**TOWN OF WEST NEWBURY
PLANNING BOARD
Tuesday May 21st, 2024 7:00 p.m.
AGENDA**

Definitive Subdivision "Eagle Nest" River Road West Newbury, Massachusetts

**Re: 125 River Road
Definitive Subdivision
Response to Peer Review #1**

DEFINITIVE SUBDIVISION
 PLAN & PROFILE
 EAGLE NEST
 WEST NEWBURY, MASS.

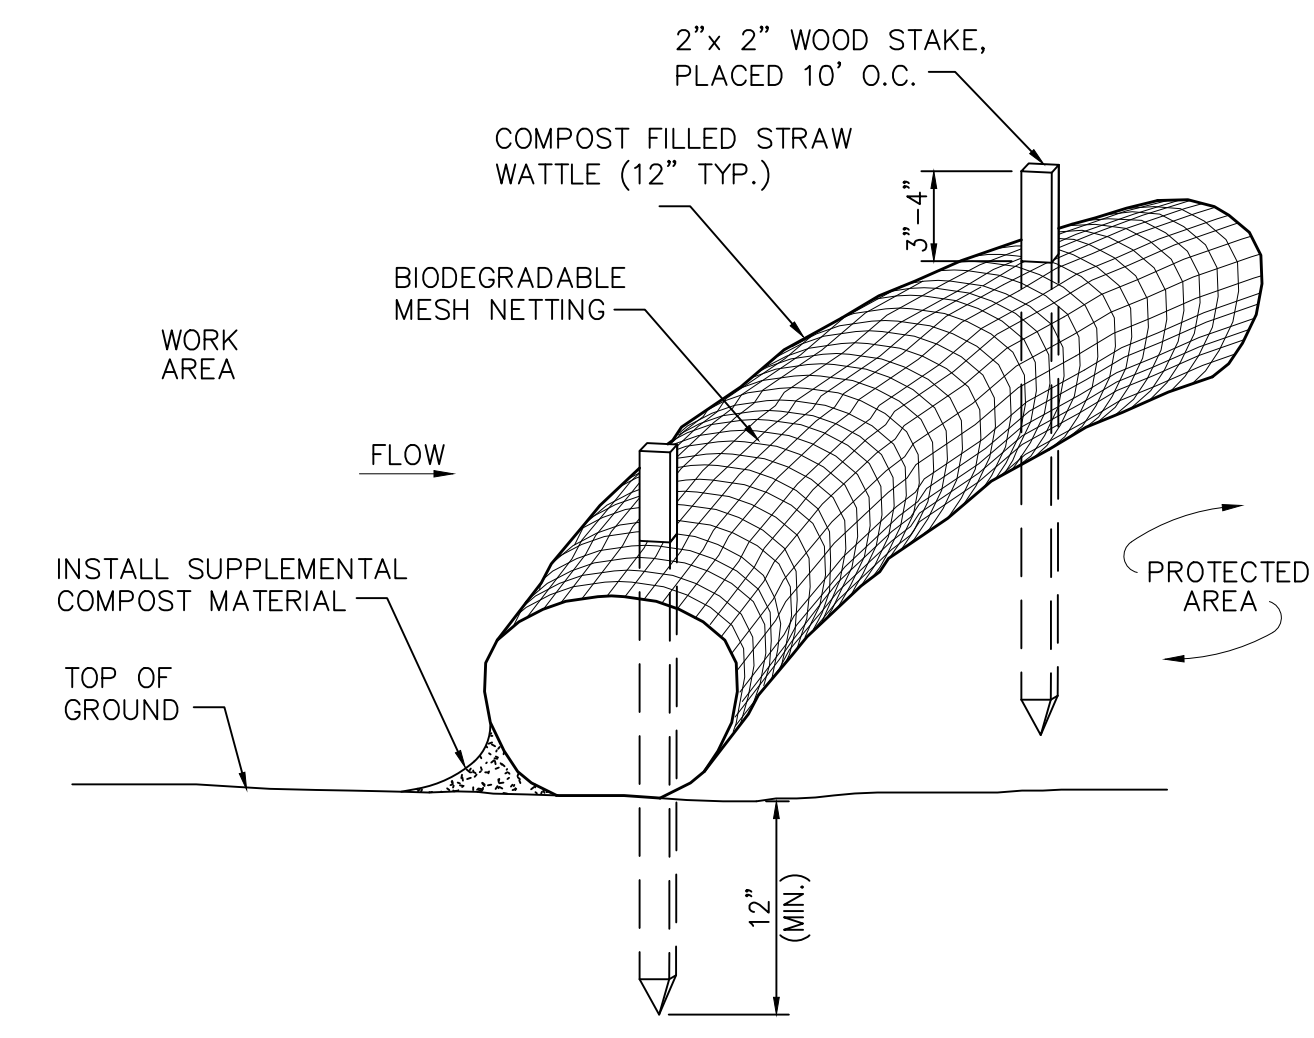
- 2. Comment: The Plan and Profile of the roadway, sheet 8 of 16, is at a scale of 1"=20' horizontally and 1"=2' vertically to more clearly depict the information on this sheet. This is a non-issue; however, it is at the discretion of the board to accept such scales.*

Response: As stated in the comment, the scale shown on the plan more clearly depicts the intent of the design and we would request the Board allow the scale as shown.

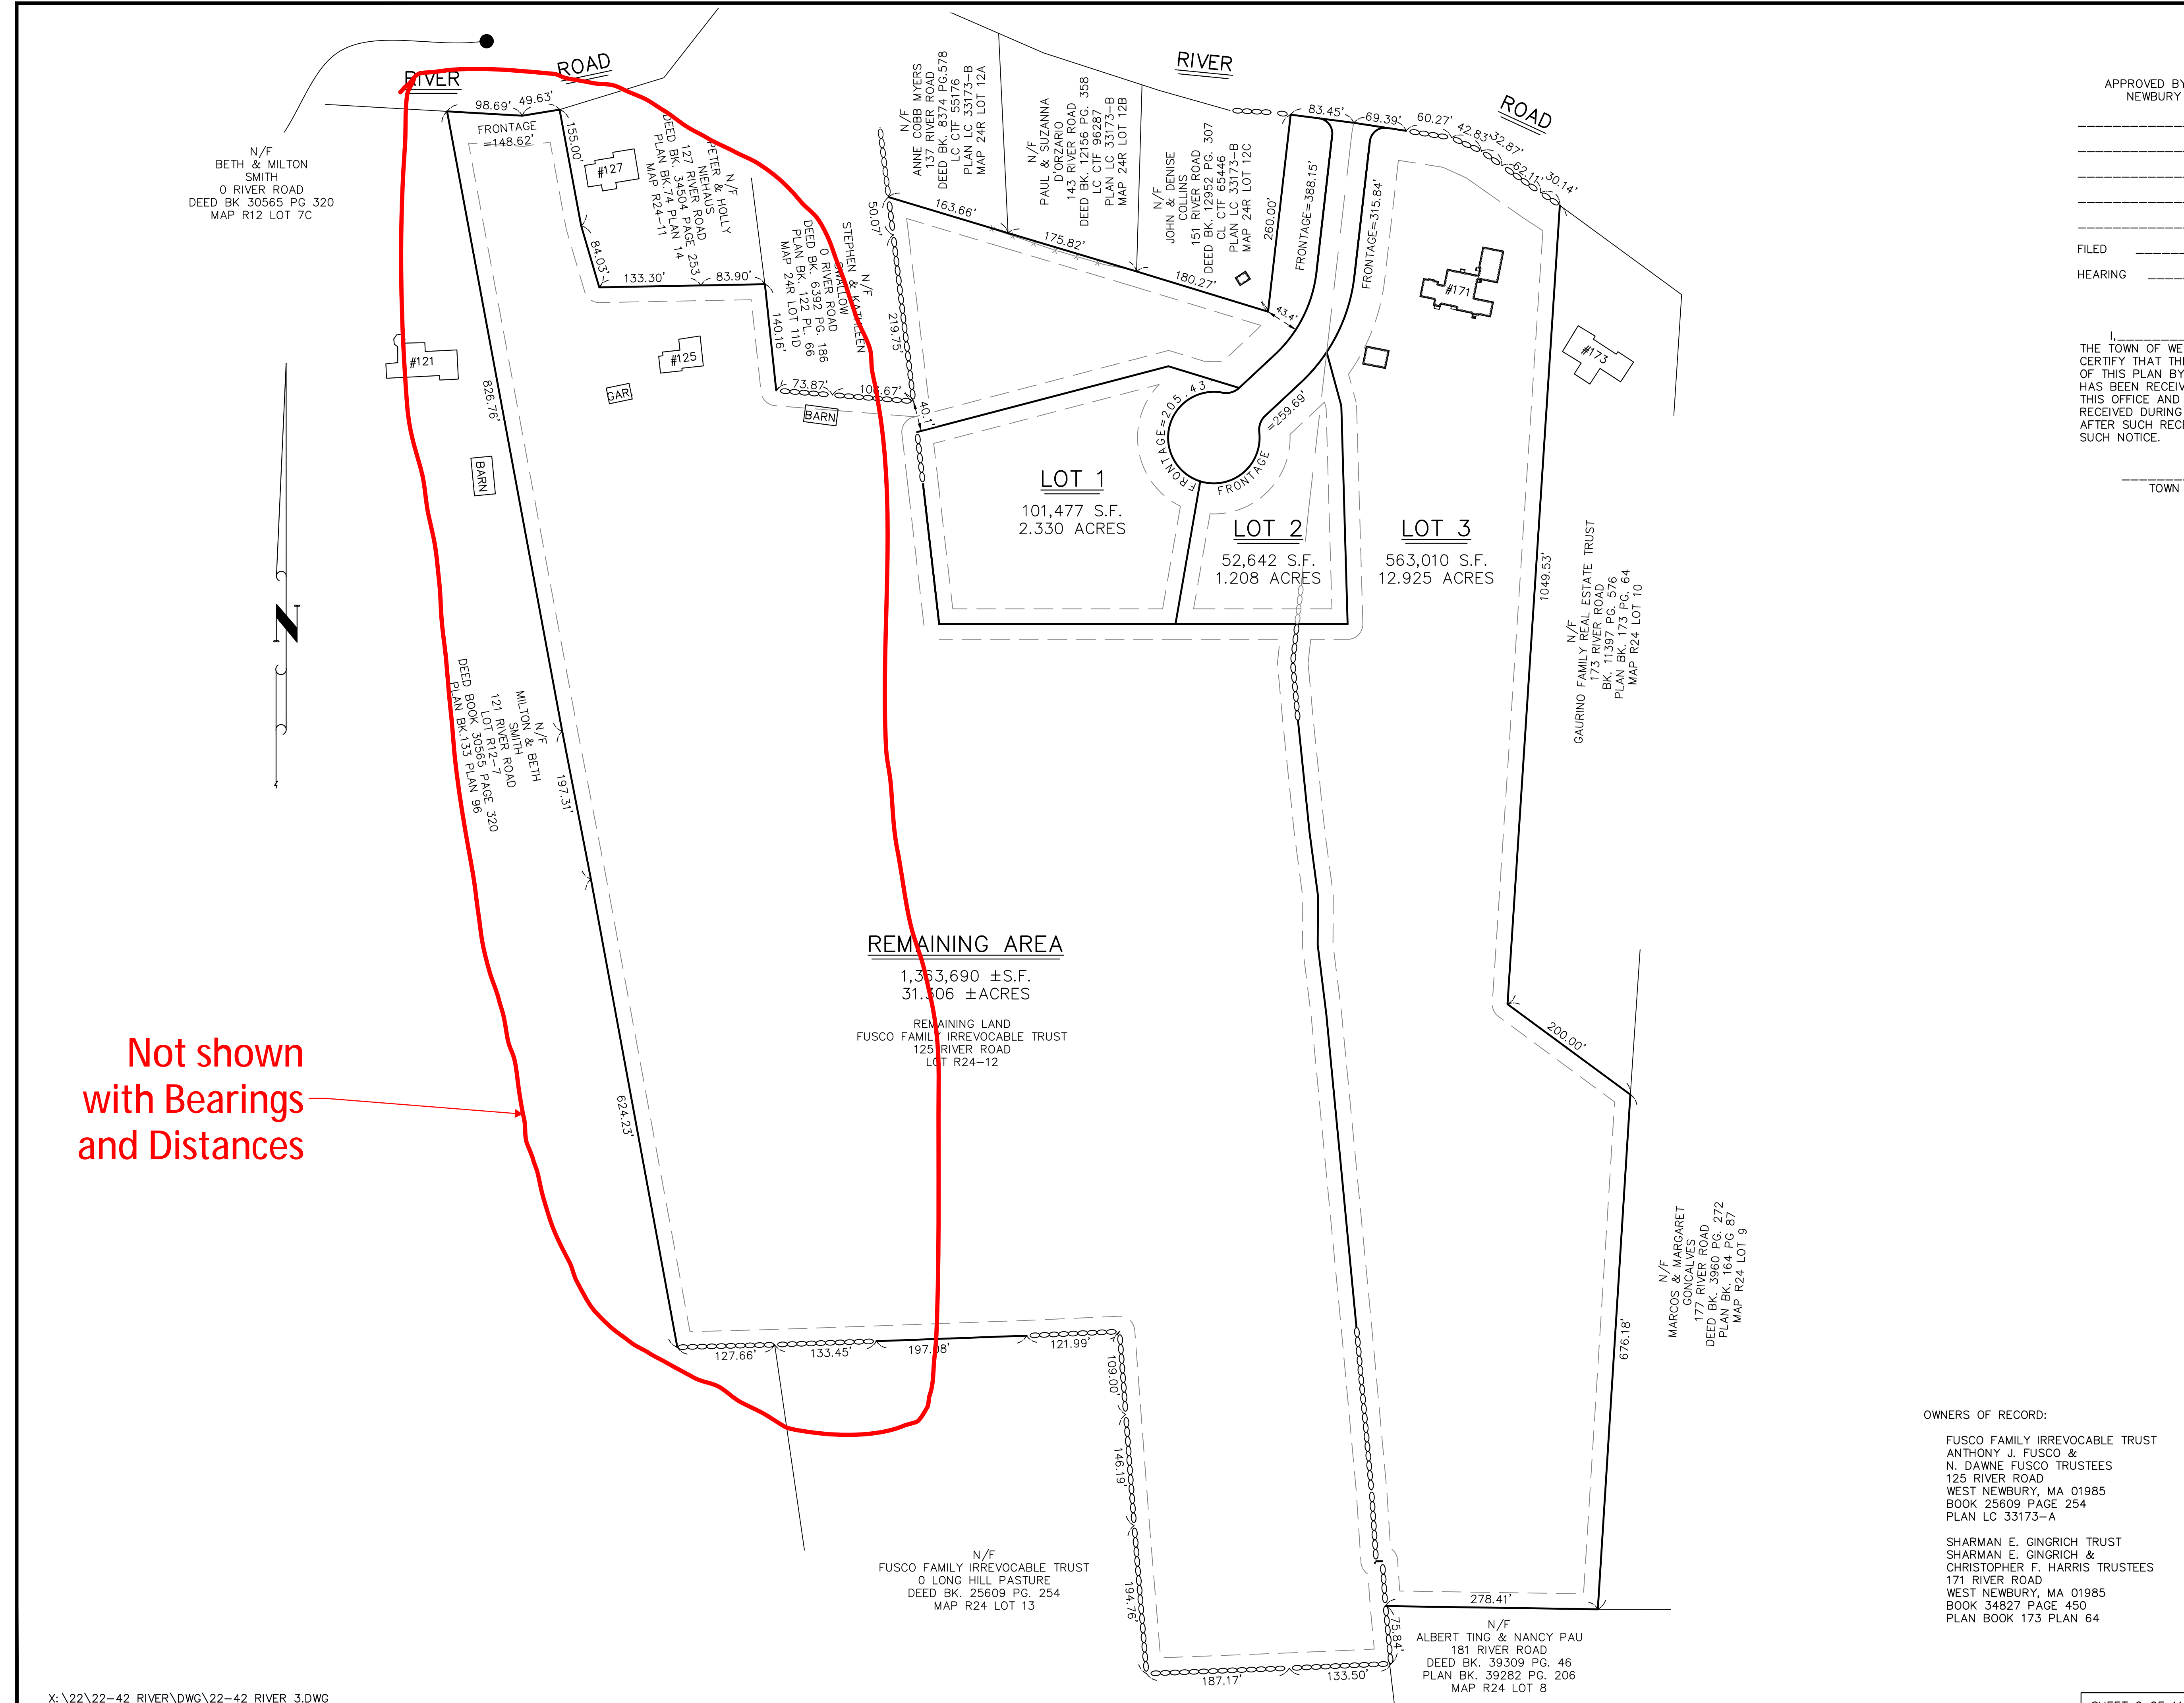
Although Sheet 2 of 11 shows the distances of the boundary of the entire subdivision property, it still does not appear as though bearings and distances for the western portion of the ‘Remaining Land’ have been provided. Please provide the boundary information as required.

Not shown with Bearings and Distances

**DEFINITIVE SUBDIVISION PLAN
LOTTING SHEET 2 OF 3
EAGLE NEST
WEST NEWBURY, MASS.**

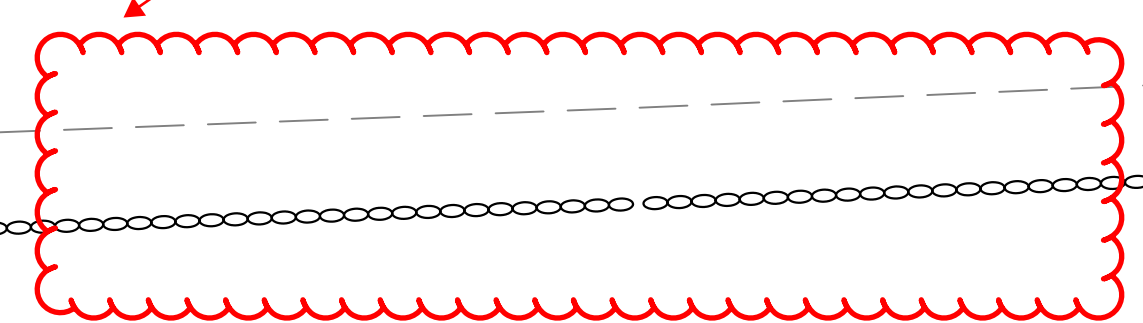
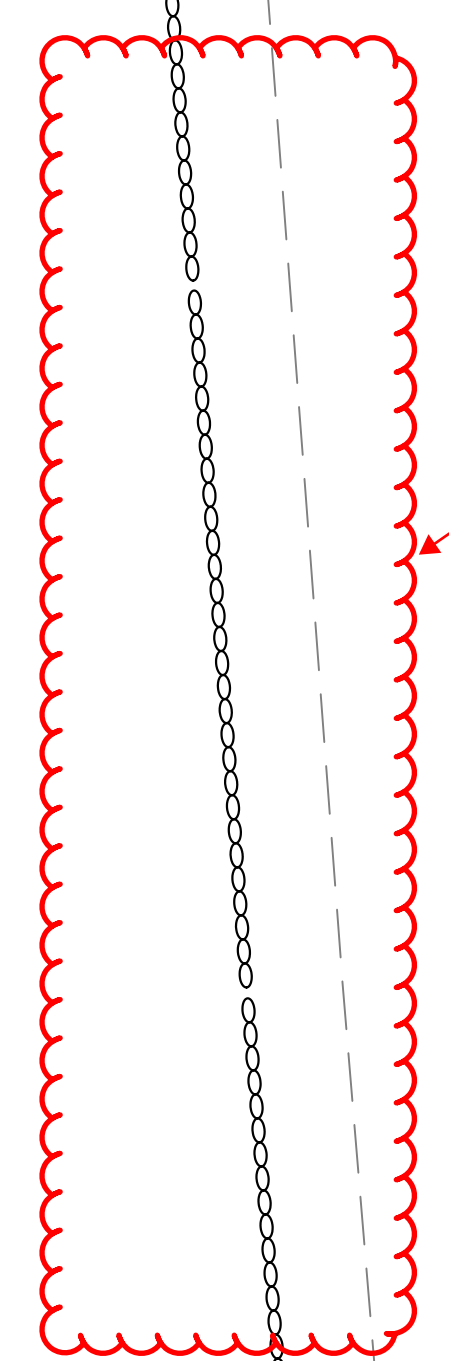
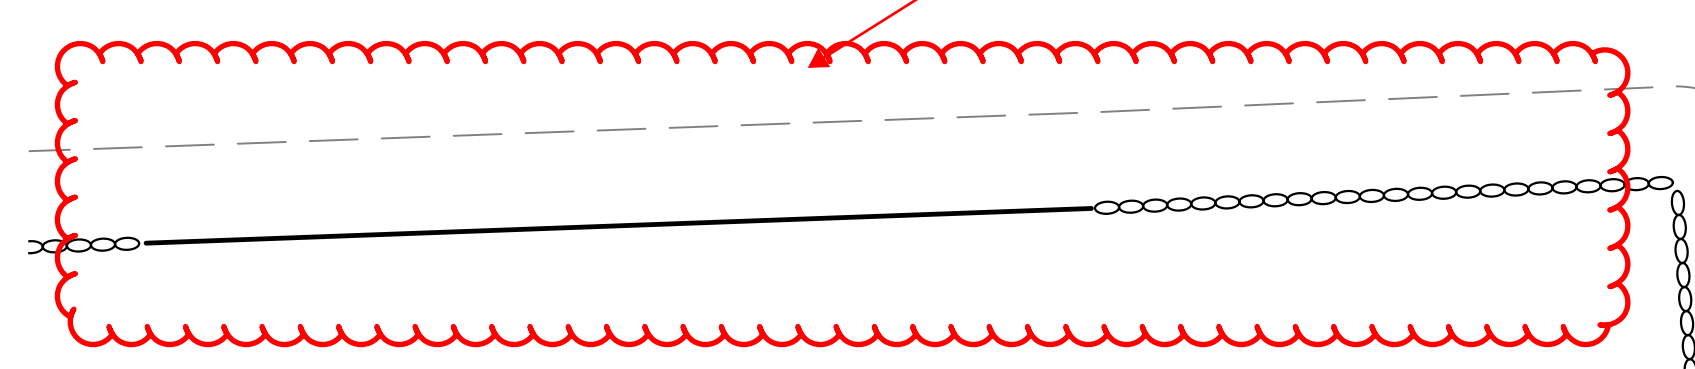
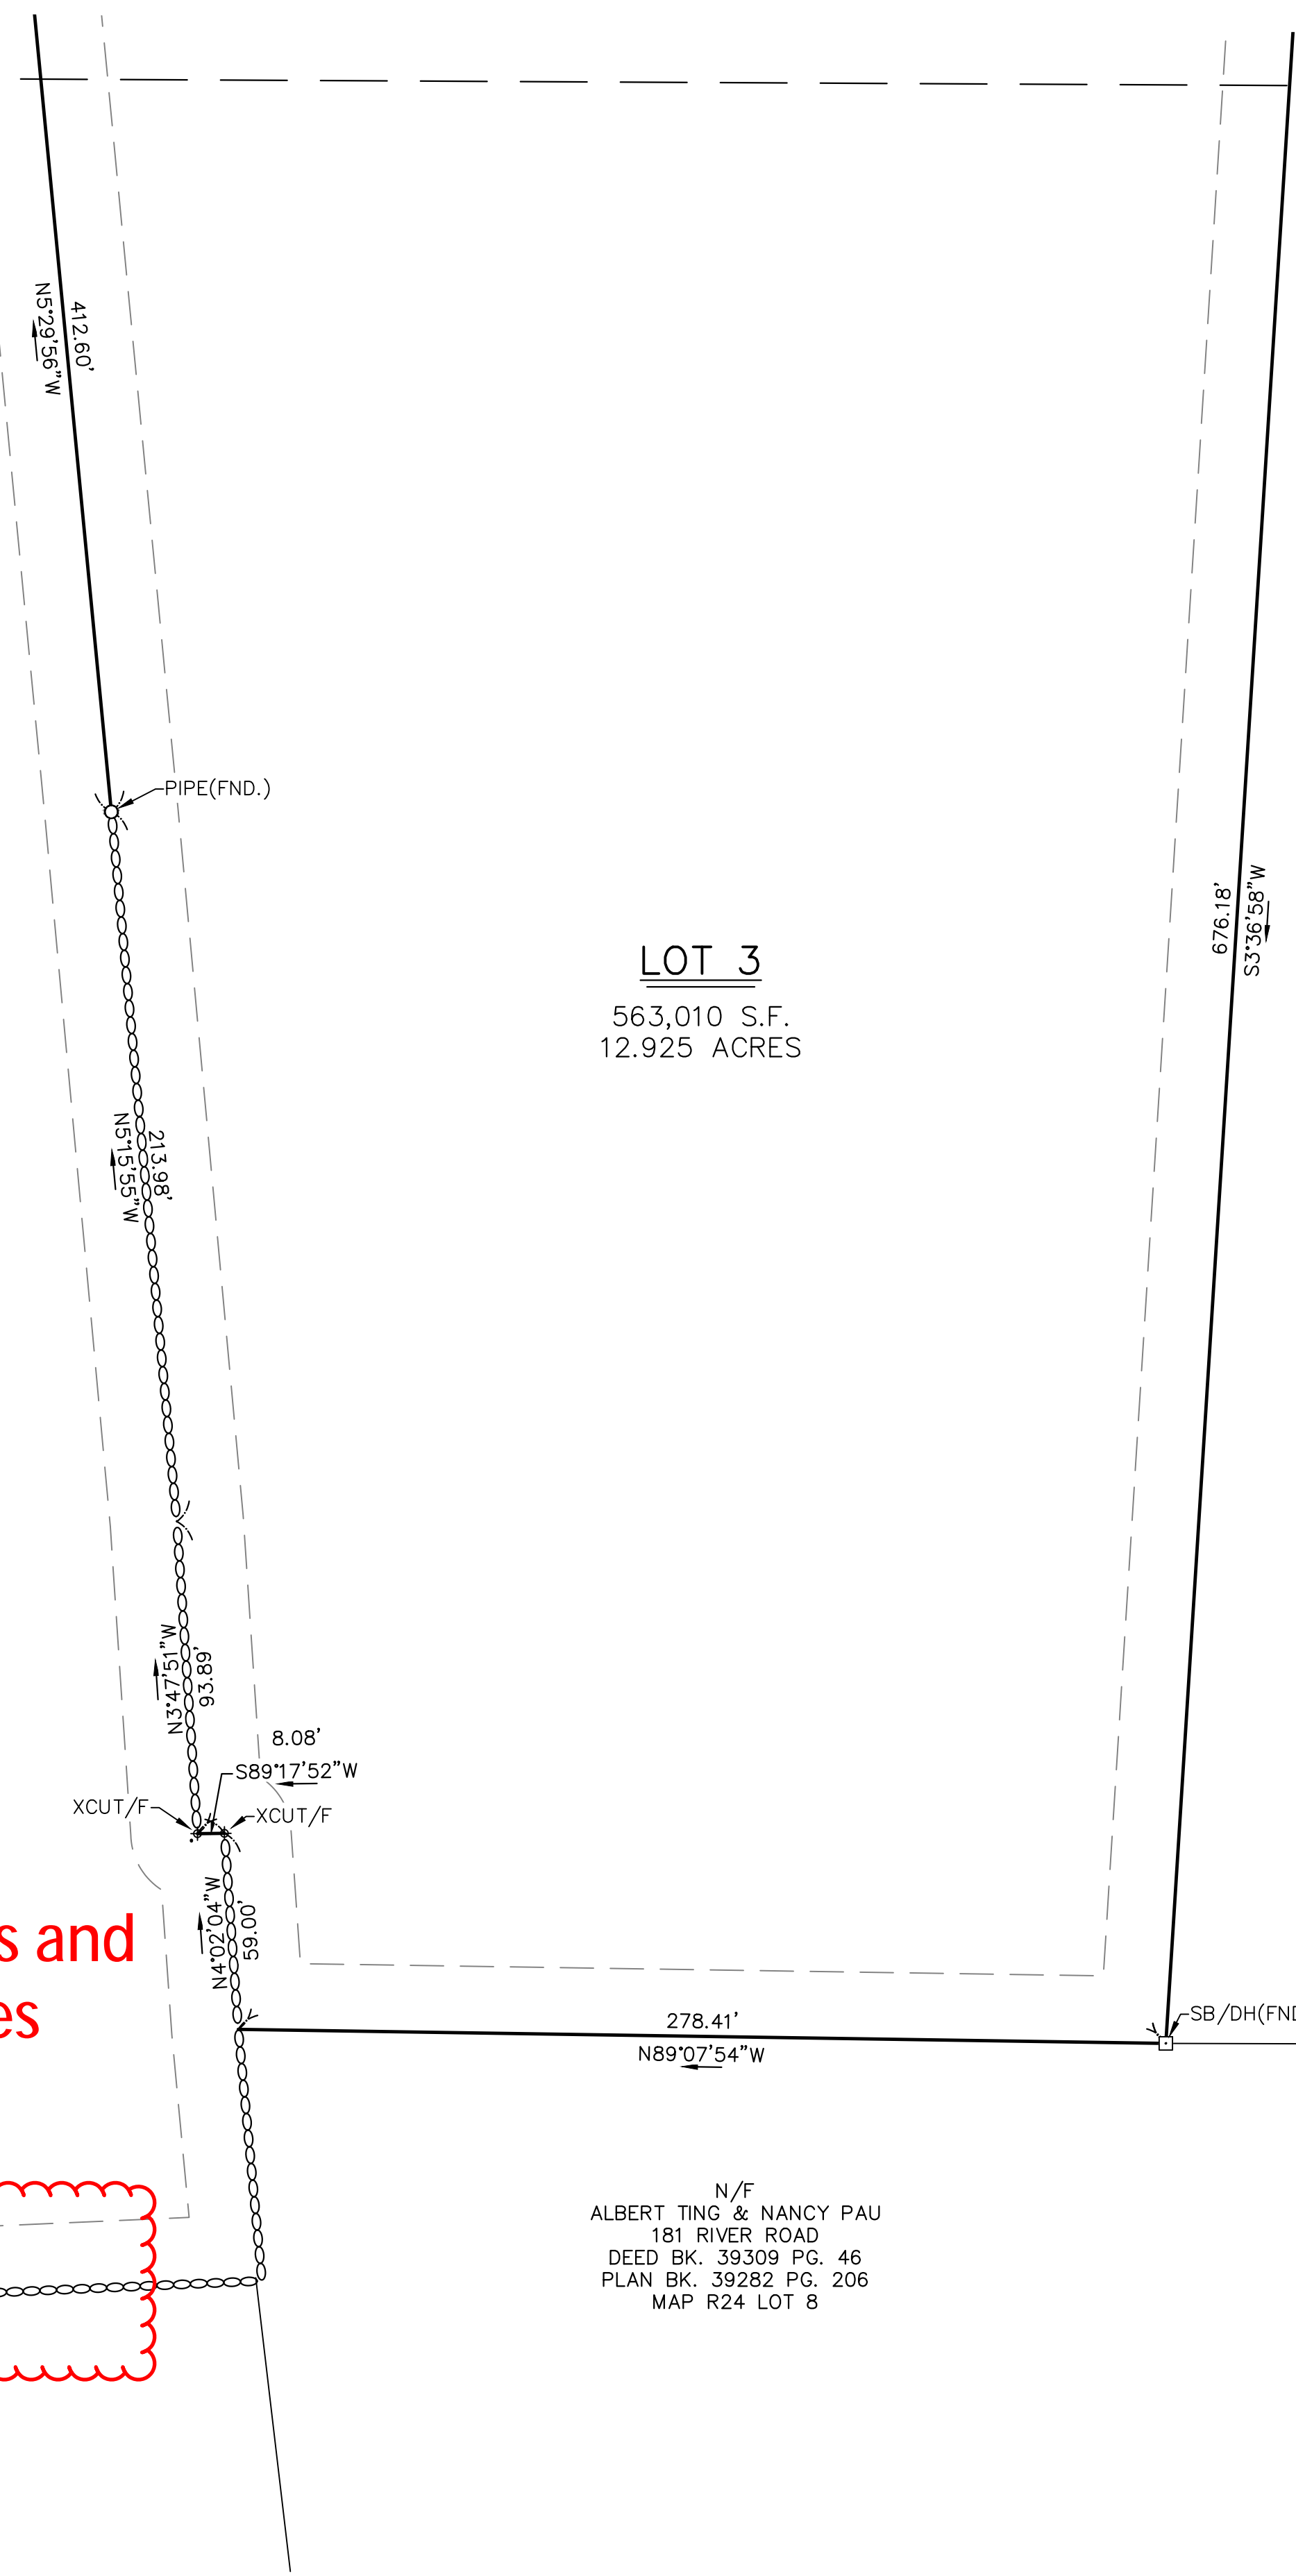
Bearings and distances

Bearings and distances

8' DIAMETER CRUSHED STONE SETTLING POOL
 NOT TO SCALE

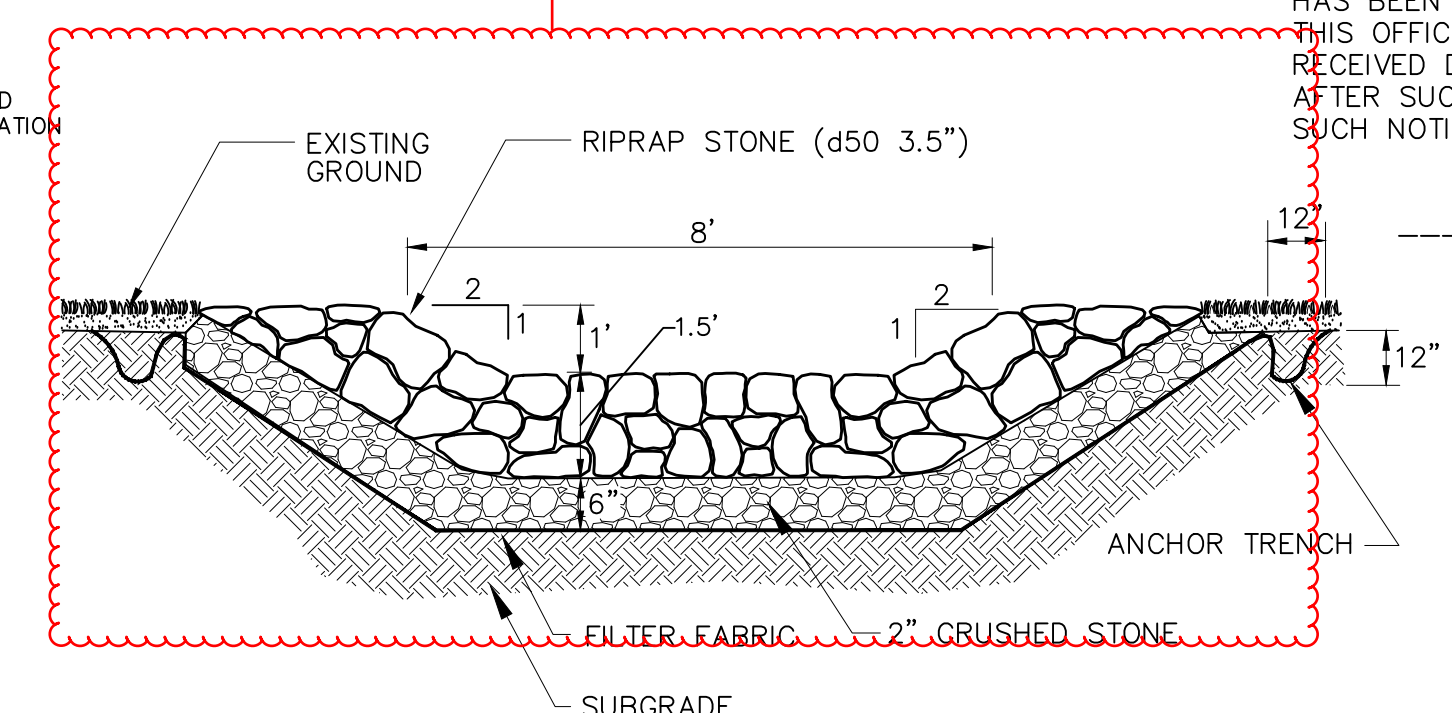
Provide elevations
